Technical Memorandum for 340 West 31st Street, New York, New York
EAS and Negative Declaration
CEQR Number 10DCP033M
ULURP Number M120085AZSM
November 13, 2015

I. INTRODUCTION

Seal & Signature _____
Date: 10/01/2015
Project No: 2013-48
Drawn by: YMS, WX
Checked by: WQB
Drawing No.
A-002.00

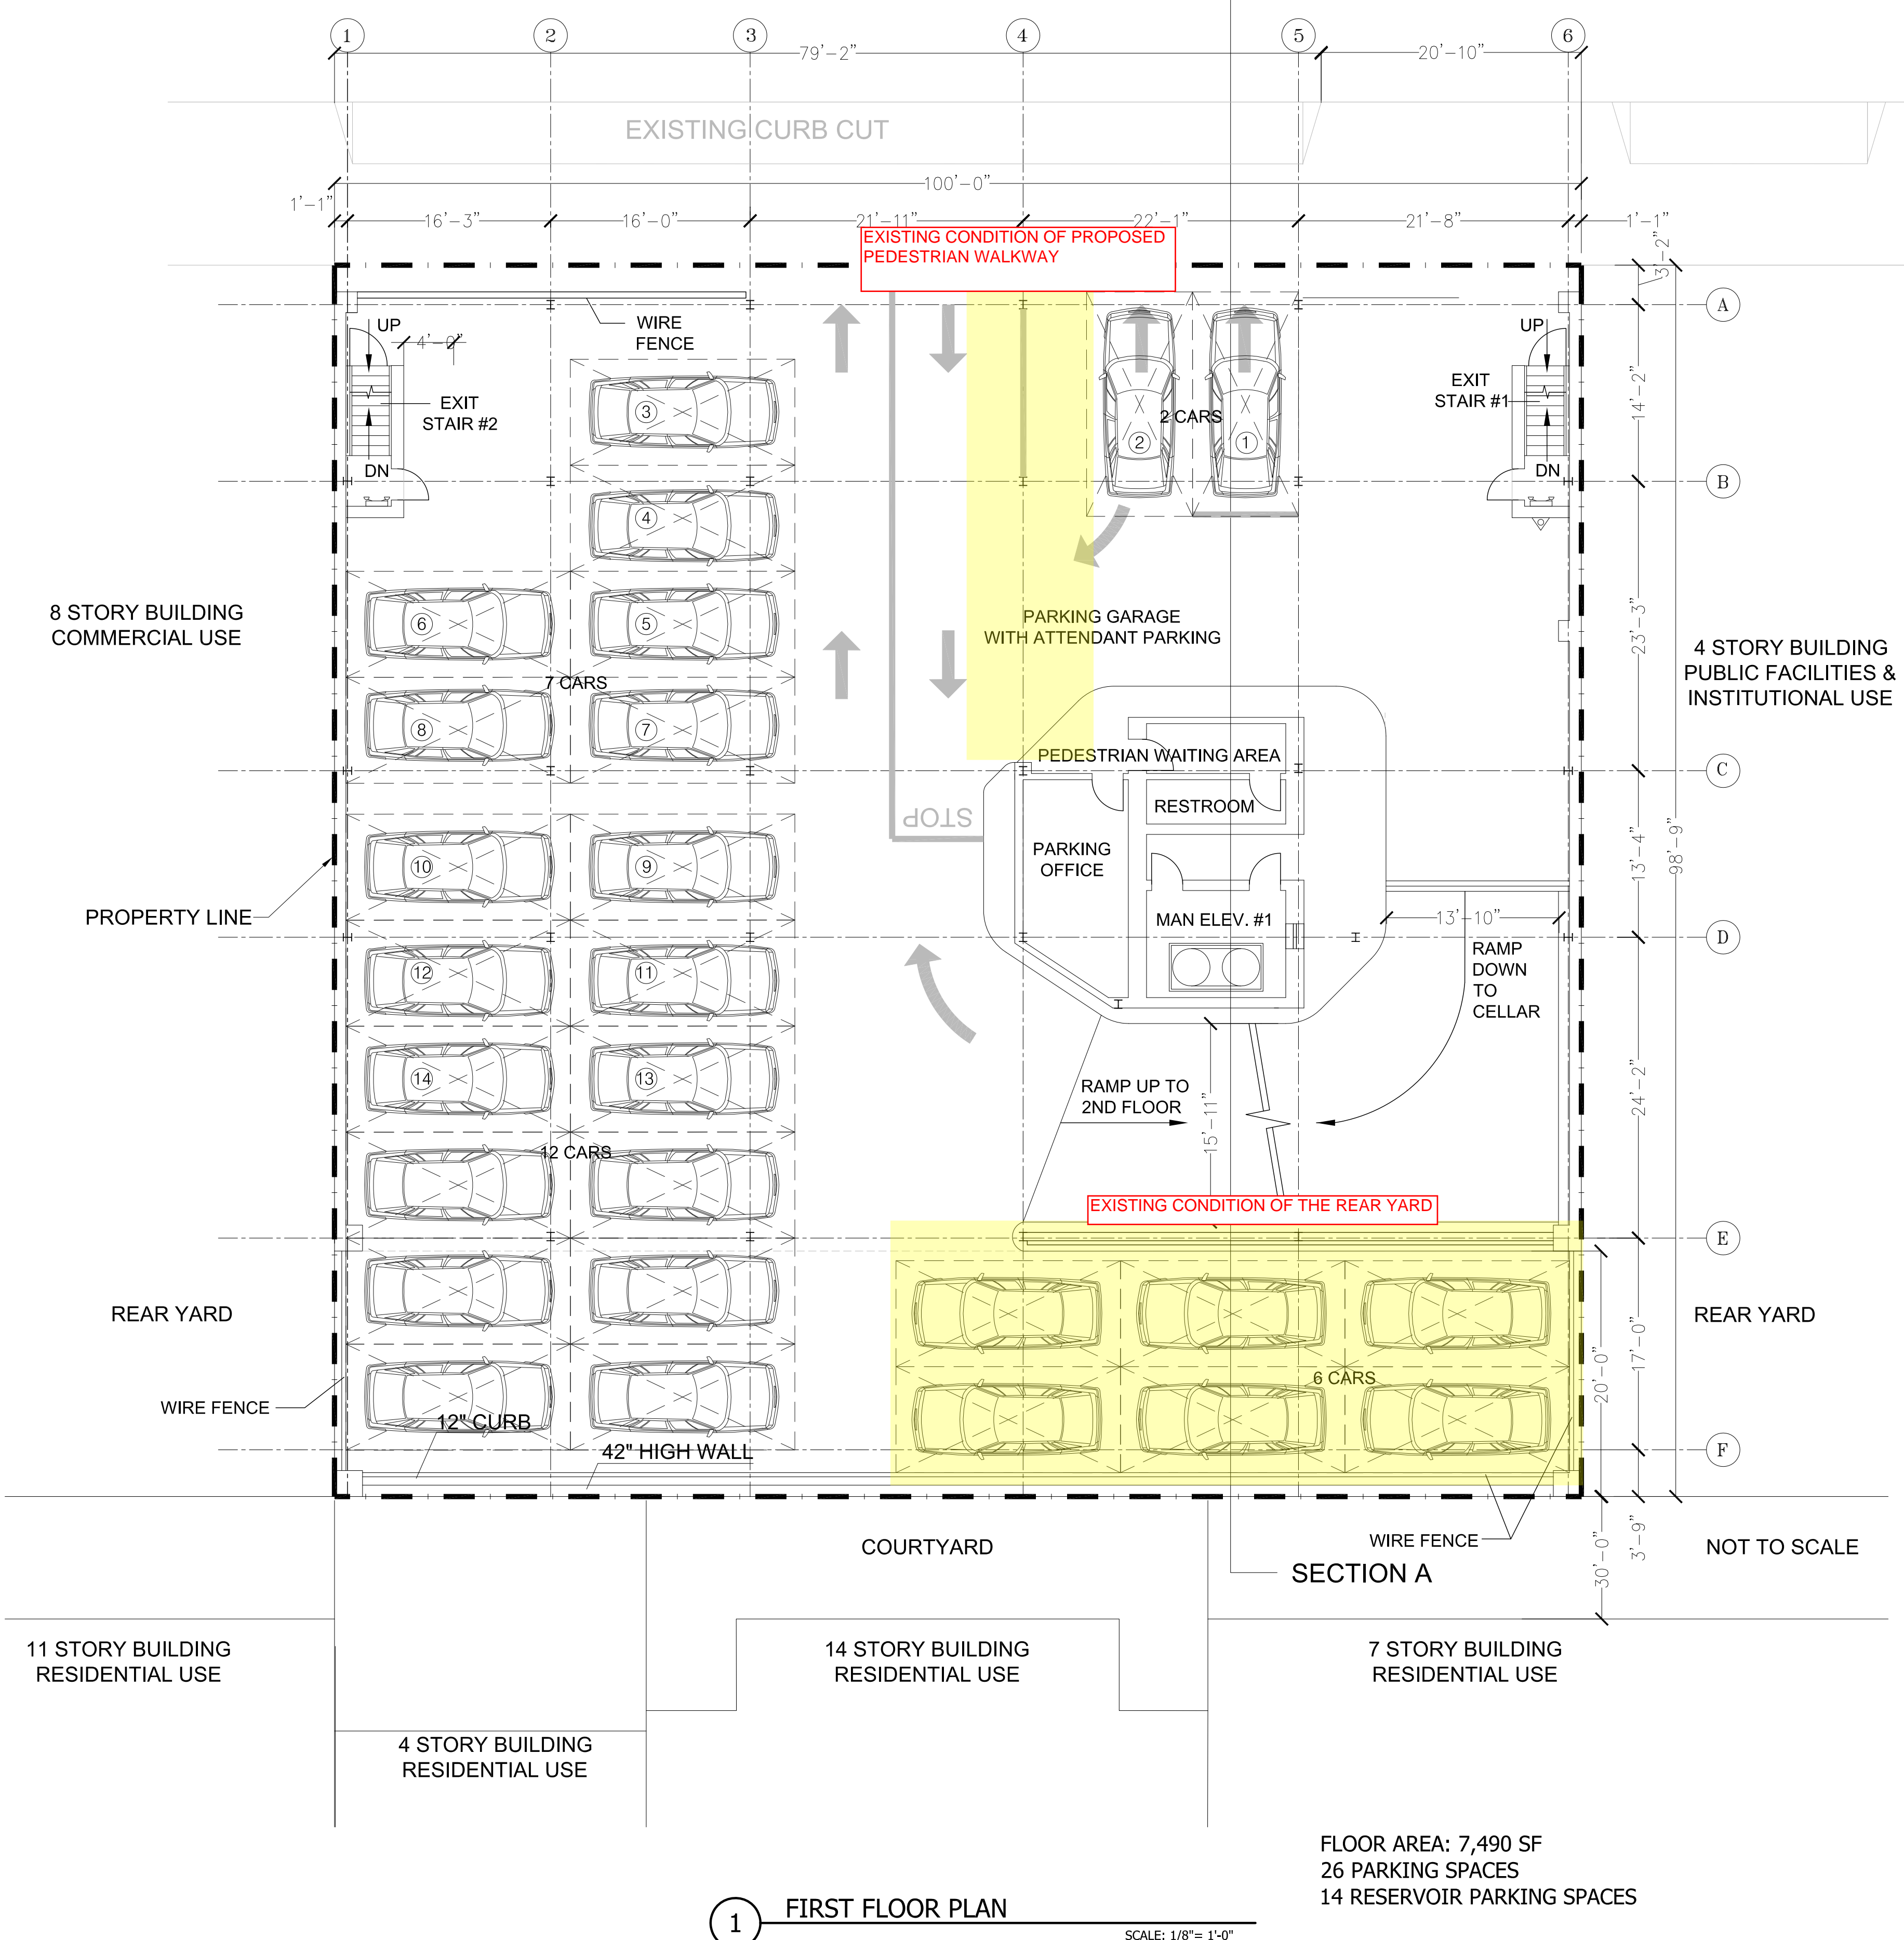
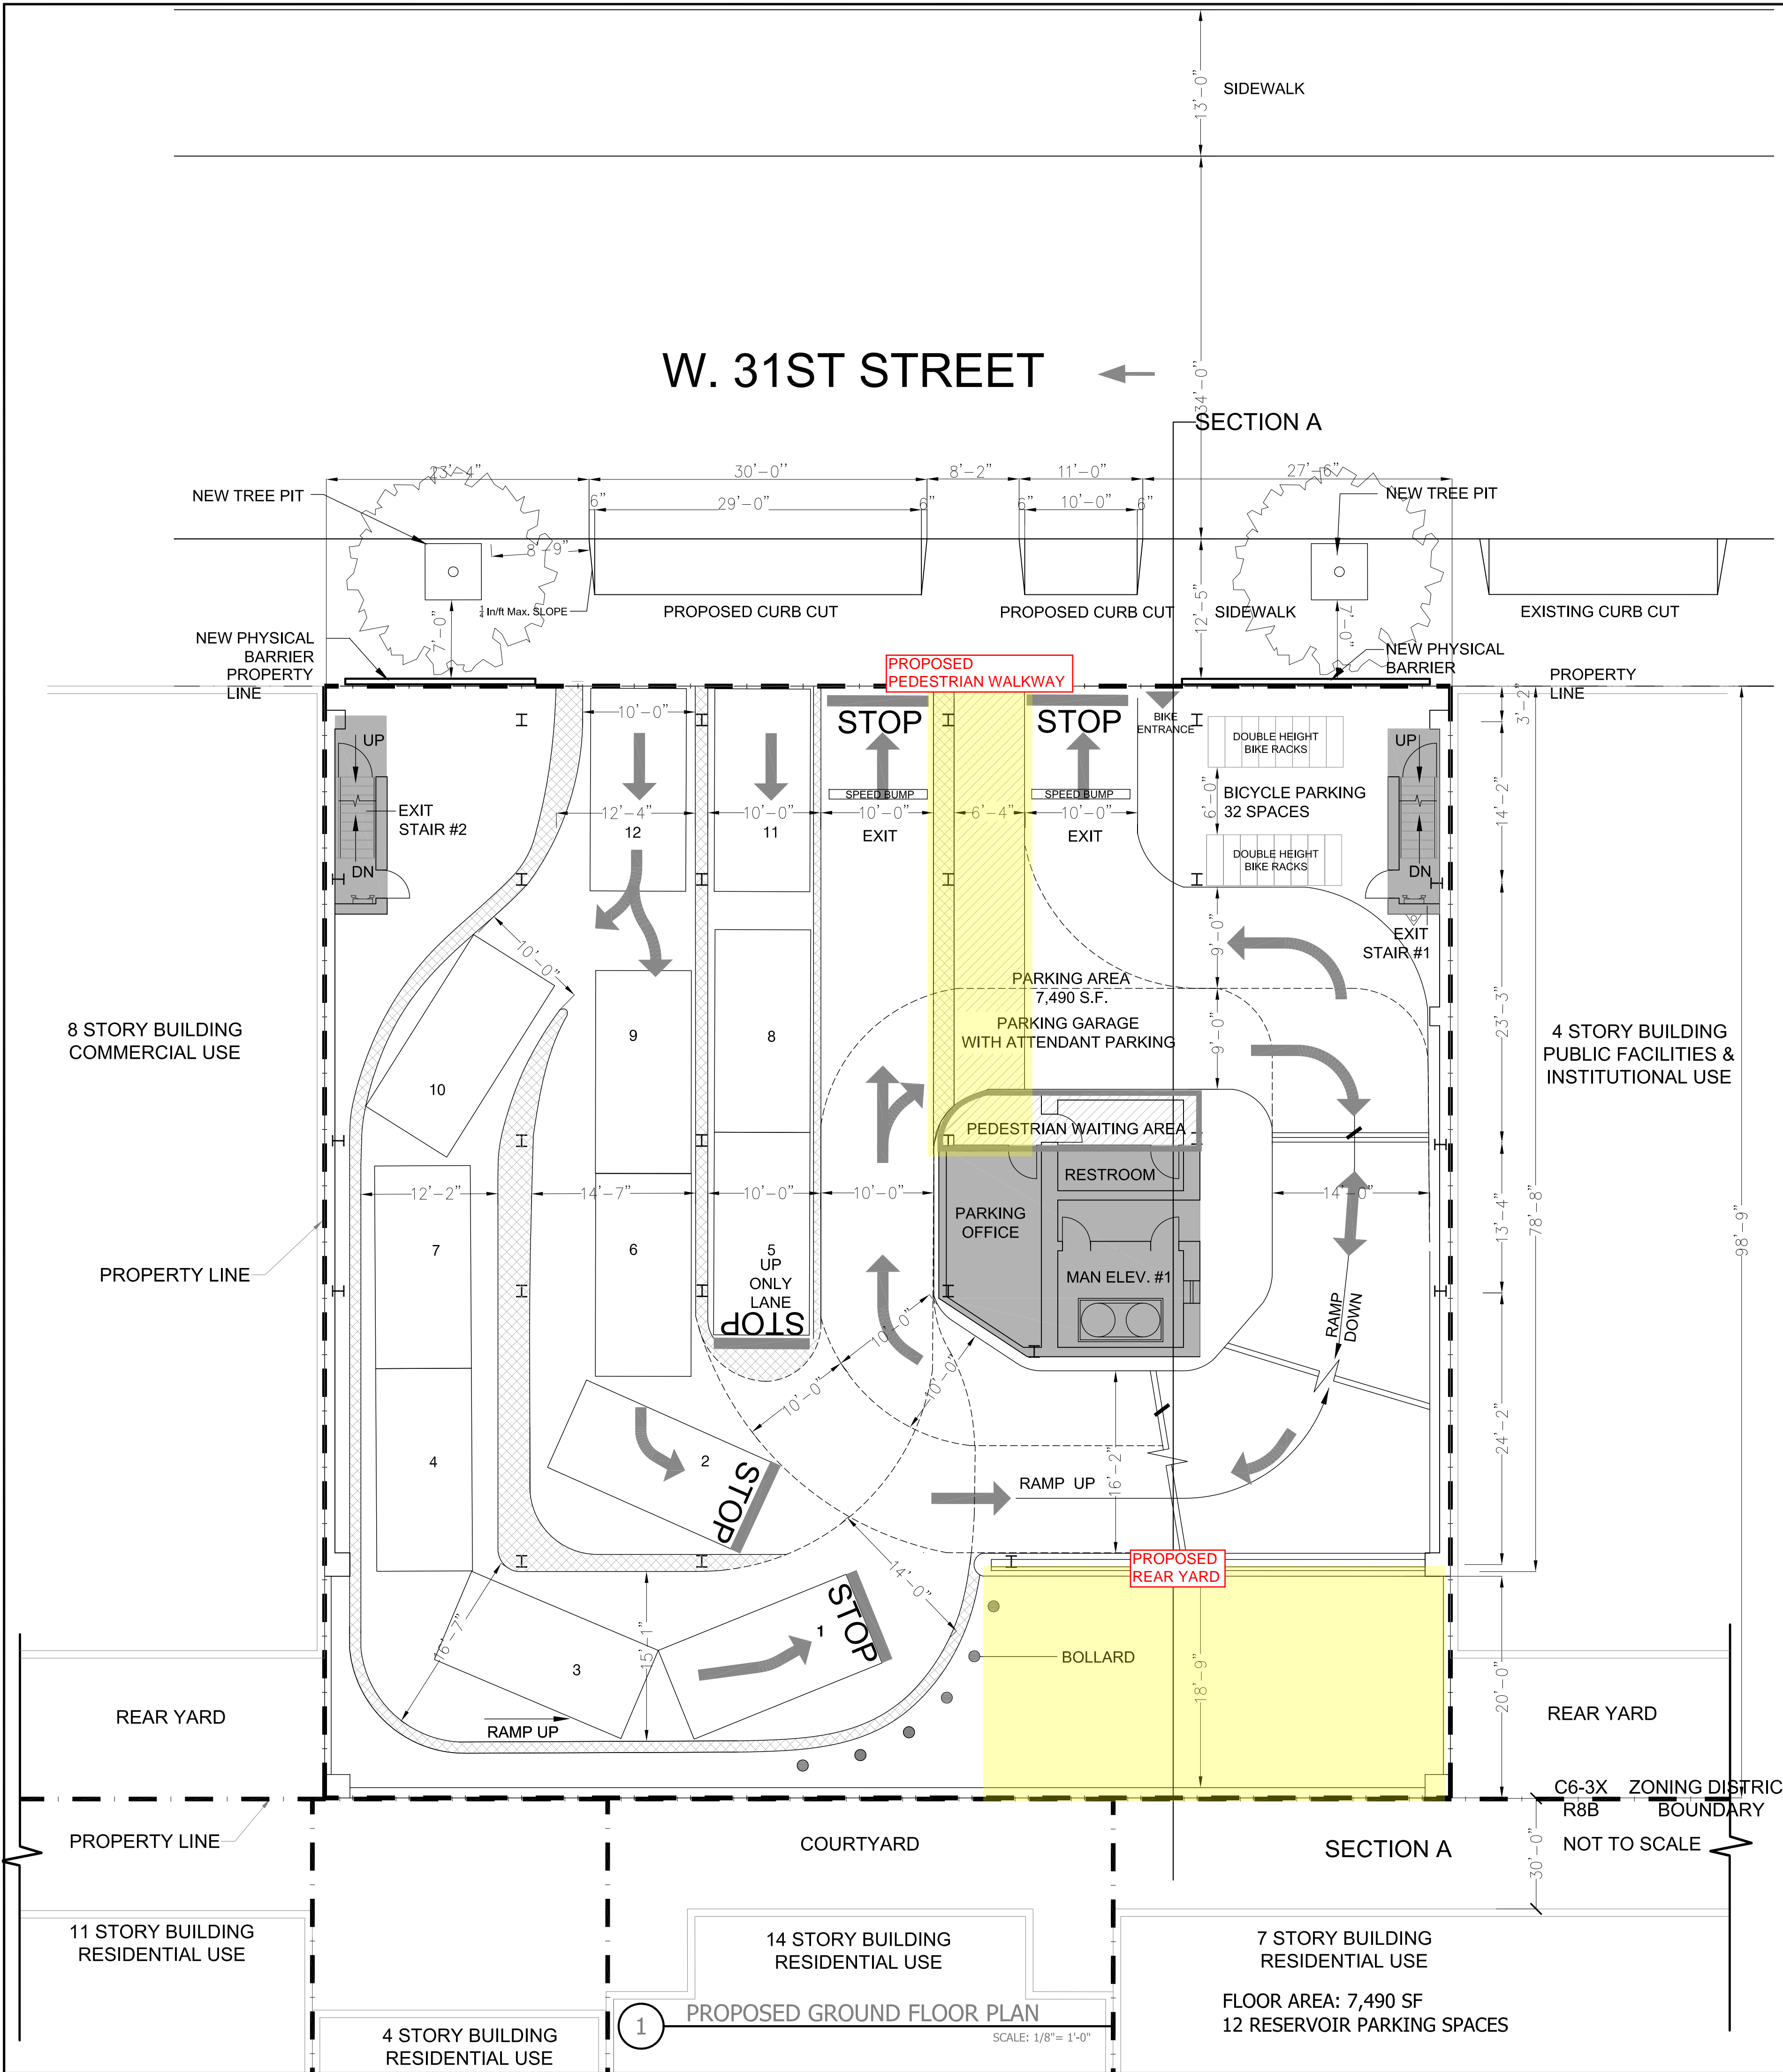
The proposed action would divide the existing 79-foot curb cut into two separate curb cuts of 30-feet and 10-feet wide curb cuts. The 30-foot curb cut would provide access to one 10-foot, one 11-foot wide entrance lanes, and one 10-foot wide exit lane. The 10-foot curb cut would provide access to a separate 10-foot exit lane. Existing conditions are highlighted on Existing Site Plan A-001.00. The proposed modification is highlighted on Proposed Modification Drawing A-002.00.

- Streetscape improvements
Streetscape improvements that would occur on West 31st Street in front of the garage would be sidewalk trees in areas of the former curb cut not included in the proposed curb cut configuration. Existing conditions are highlighted on Existing Site Plan A-001.00. The proposed modification is highlighted on Proposed Modification Drawing A-002.00.
